Brantford Power Inc.
EB-2016-0058
OEB Staff Interrogatories

Figure 5: Reliability Trends for the Historical Period (including loss of supply)

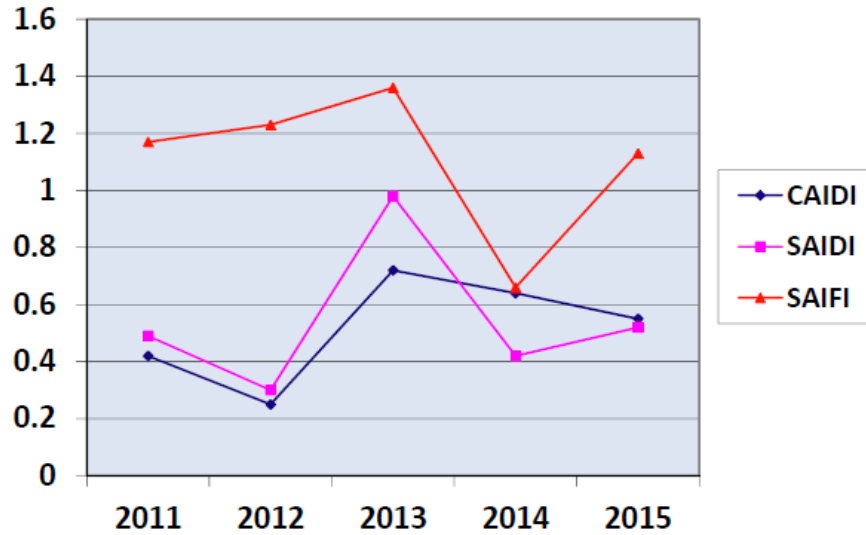
a) In a revised graph, please present the 2011 - 2015 reliability trend information in Figure 5 excluding the December 2013 event.

Figure 7: Reliability Trends for the Historical Period (excluding loss of supply)

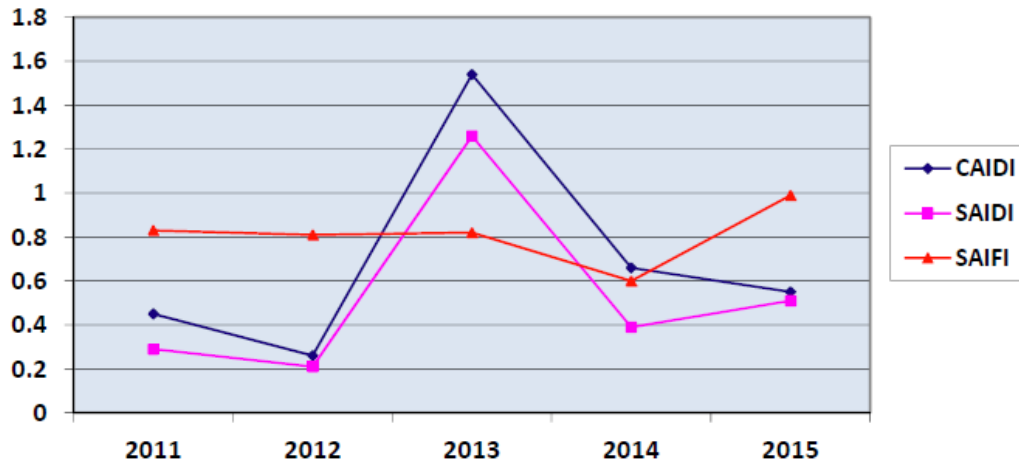
- Please explain why the values in Figure 7 are higher when excluding loss of supply than when including loss of supply (i.e.: compared to Figure 5 shown in 2-Staff-3).
- Please explain what caused the deterioration in SAIFI and SAIDI from 2014 to 2015.
- Please explain what caused the deterioration in SAIFI, SAIDI and CAIDI from 2011 to 2015.
- In a revised graph, please present the 2011 - 2015 reliability trend information in Figure 7 excluding the December 2013 event.

Figure 46: Poles Tree Diagram

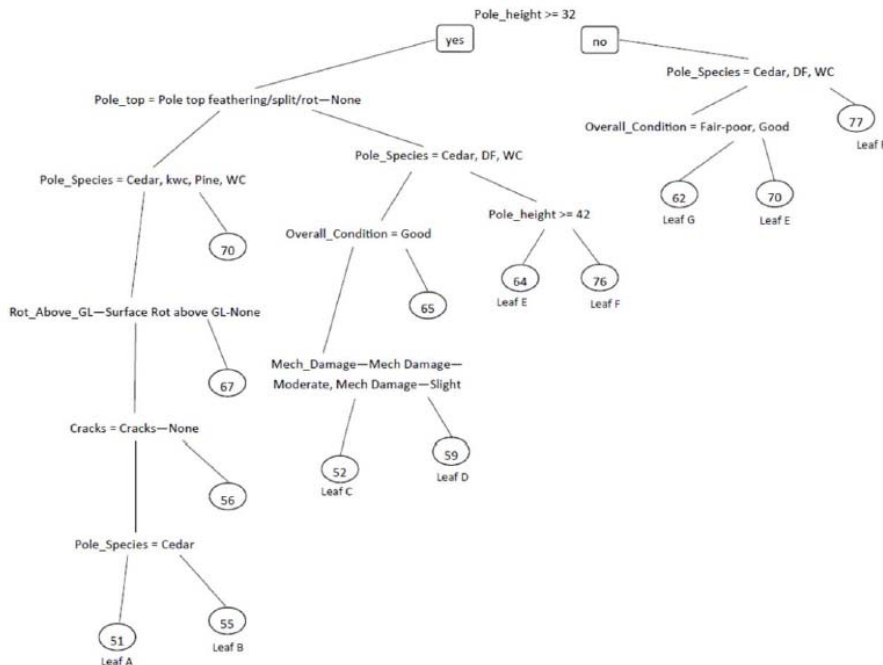
- a) Please identify the decision criteria used at each bifurcation point in the tree diagram shown in Figure 46 (or confirm that the assumption in each case is left branch = "Yes" and right branch = "No").

- b) Please confirm if the circled numbers equate to the percentage of Remaining Service Life of the pole.
- If this is not the case, please provide an interpretation of the numbers.
 - If this is the case, please confirm that the tree diagram never results in a pole having a Remaining Service Life higher than “77”, or lower than “51”.
